This document transmits the Initial Issue of Service Bulletin EV2500-73-0190 and the Initial Issue of the Supplement

V2500-ENG-73-0190
Transmittal - Page 1 of 2

ENGINE – FUEL AND CONTROL – TO PROVIDE A NEW ELECTRONIC ENGINE CONTROL (EEC) WITH D5
SCN14/0 SOFTWARE

Location of the Electronic Engine Control (EEC)
Figure 1

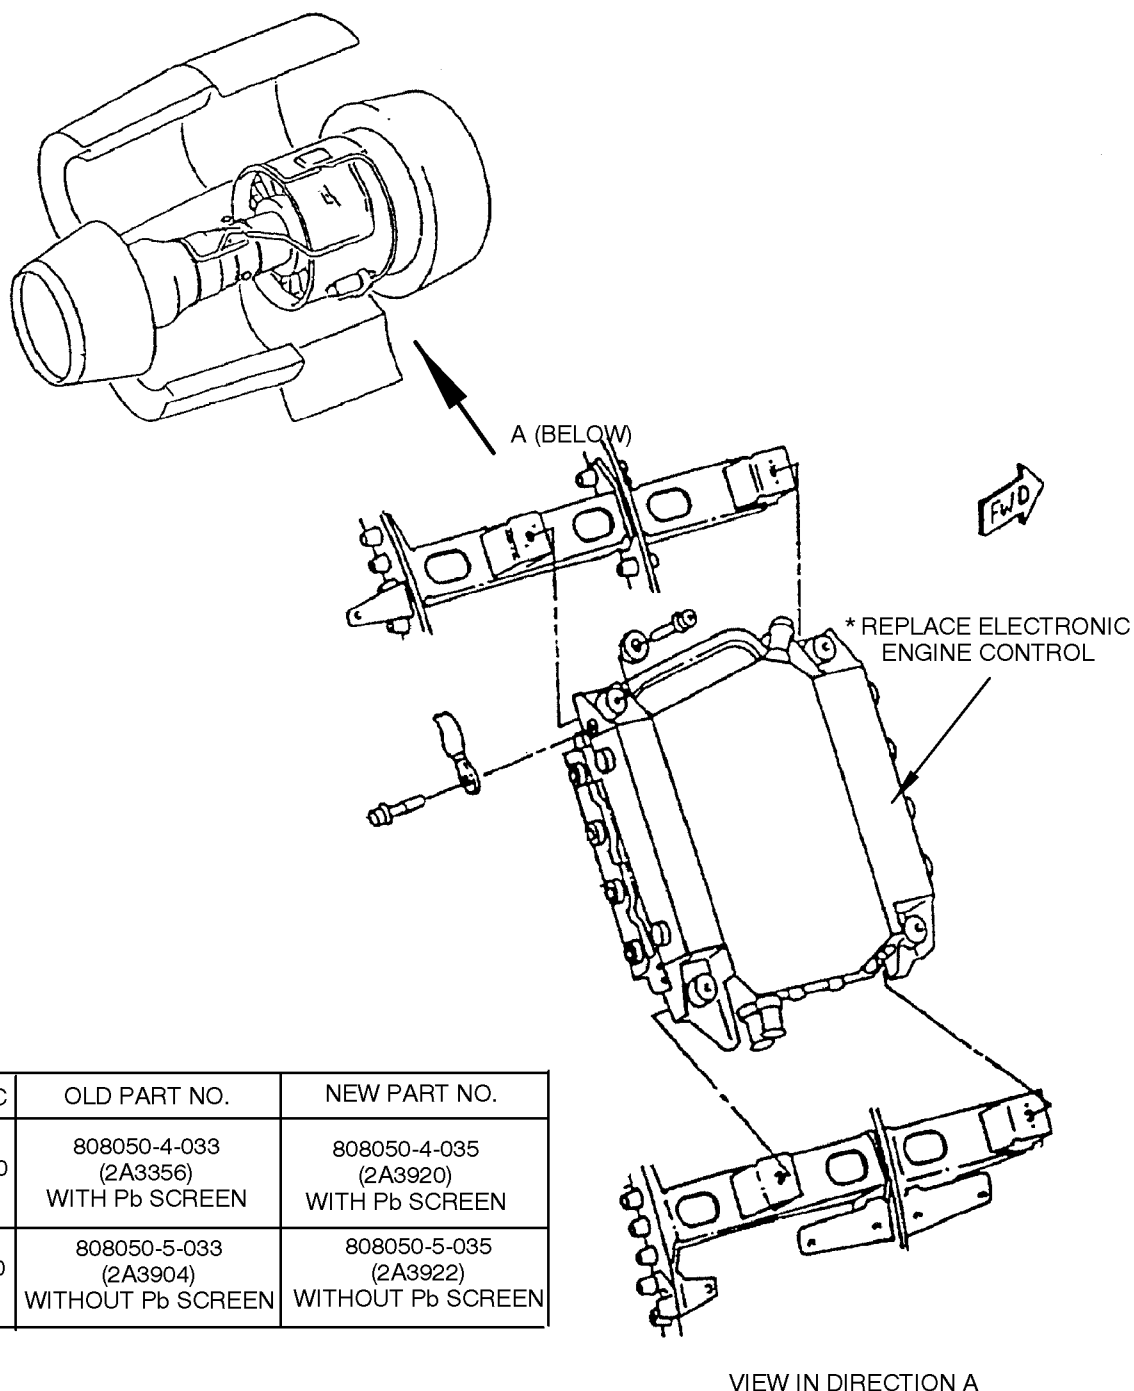
* EEC	OLD PART NO.	NEW PART NO.
150-20	808050-4-033 (2A3356) WITH Pb SCREEN	808050-4-035 (2A3920) WITH Pb SCREEN
150-20	808050-5-033 (2A3904) WITHOUT Pb SCREEN	808050-5-035 (2A3922) WITHOUT Pb SCREEN

Parts Progression To Show the Changed Part in Relation to Other Parts

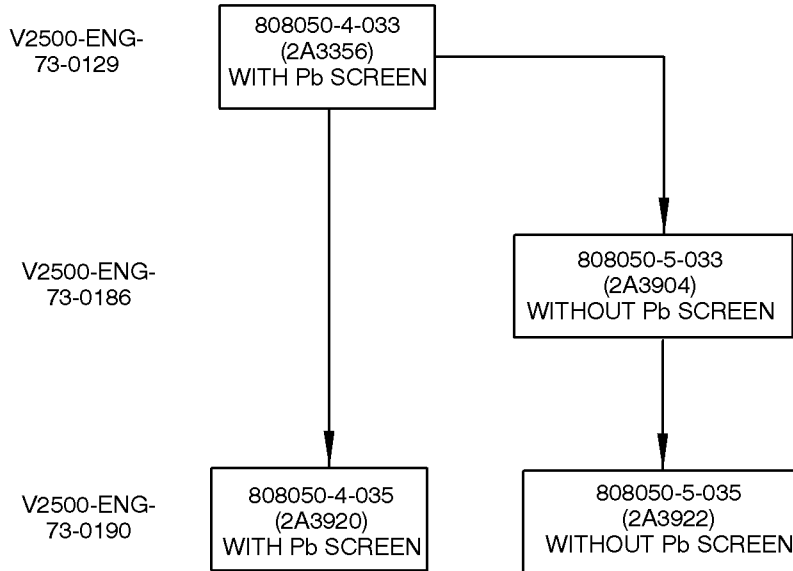
PART NUMBER CHANGE
